Service Bulletin:

SRM Pigtail Interference with vDrive When No Down Force Sensor Present

March 24, 2014

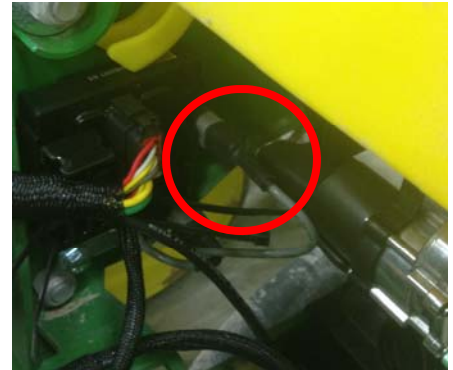
On vDrive rows where no down force sensor is plugged into the SRM, the plug that is on the SRM pigtail for the down force sensors will contact the vDrive when both are installed (see picture at right). To resolve this interference, follow these steps:

On the affected row, remove the dust cap that is molded into the SRM housing by clipping the tabs or breaking it backwards.

Insert the dust cap that you just removed from the SRM onto the 4-pin down force sensor pigtail on the SRM.

Zip tie the pigtail to the ladder rack with the dust cap pressing against the top.

Note: On rows with a vac sensor, position that sensor with the tubes coming out sideways. Then press the dust cap against the vac sensor.
